# **Analysis of In-Vessel Retention and Ex-Vessel Fuel Coolant Interaction for AP1000**

**Energy Research, Inc.**

**U.S. Nuclear Regulatory Commission  
Office of Nuclear Regulatory Research  
Washington, DC 20555-0001**

Figure 2.1a Schematic of the melt pool configuration I in the lower head (two layers)

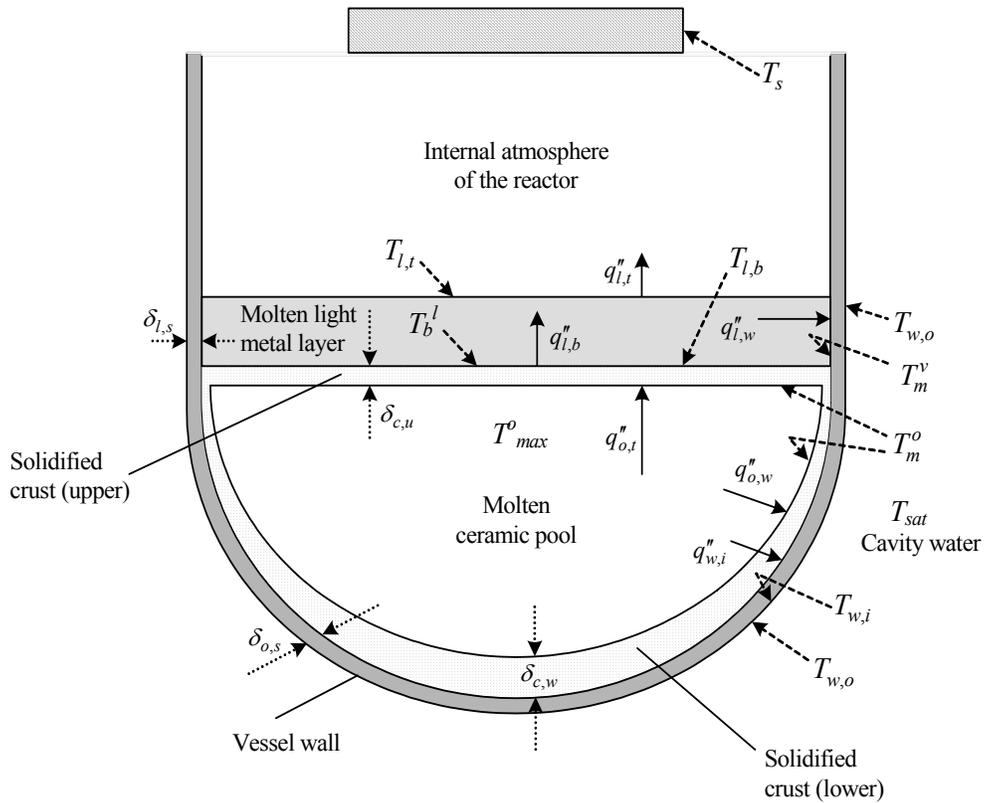
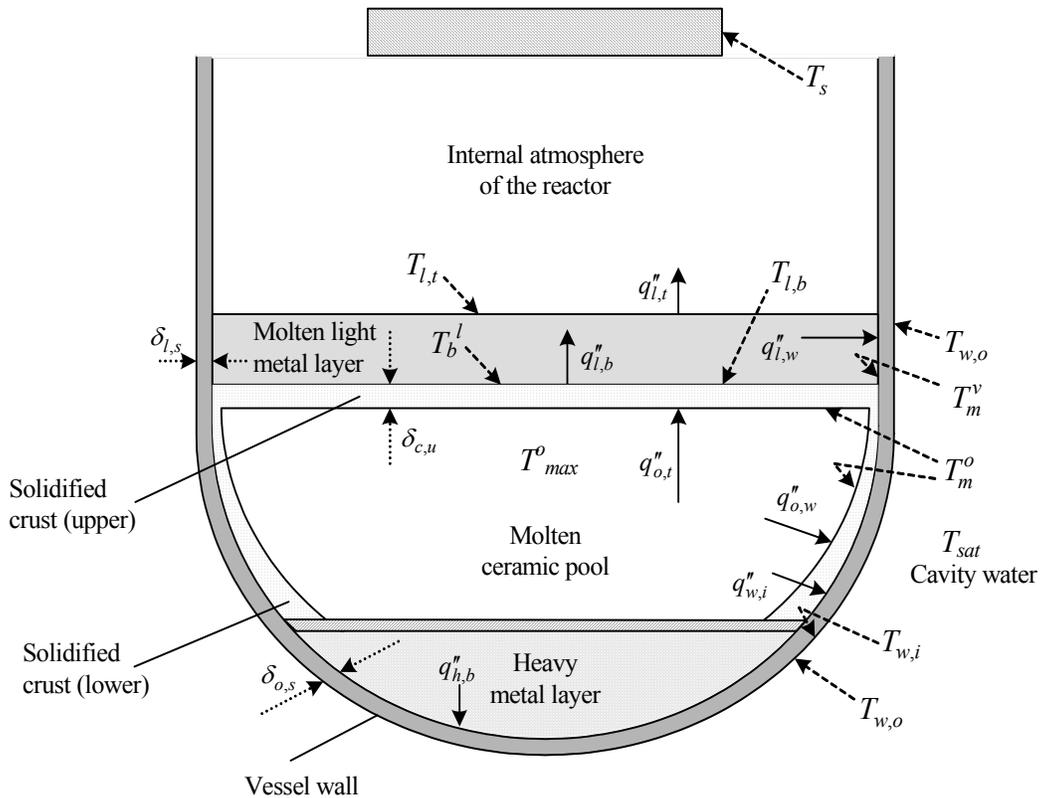
- a. Figure 2.1 shows a crust at the bottom of the light metal layer whereas on the top of page 8 of the report (limitation 2), it is stated that there is no crust.

- a. *The crust shown in Figure 2.1 is the upper ceramic crust which is just below the light metallic layer. The limitation refers to a metal crust in the metallic layer.*

Figure 3.4 Relationship of stainless steel in the lower plenum and the ceramic mass for AP1000

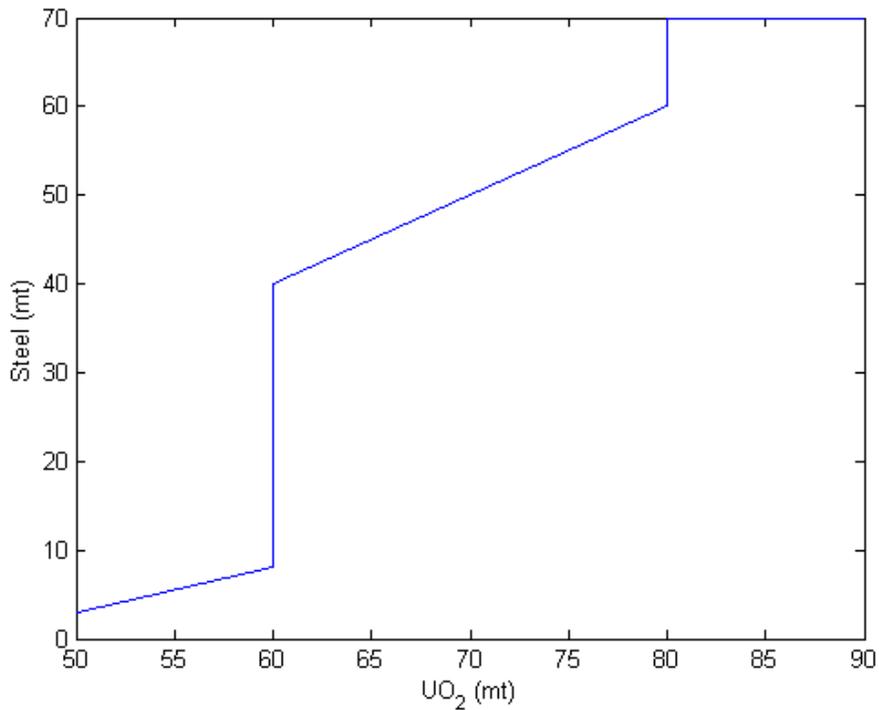
- In equation (3-1), superscripts should be defined.
  - Figure 3-4 shows that amount of stainless steel in the lower plenum increases from 40 to 60 mt when the amount of  $UO_2$  is increased from 60 to 80 mt, but this is not what is stated in the text on page 34.
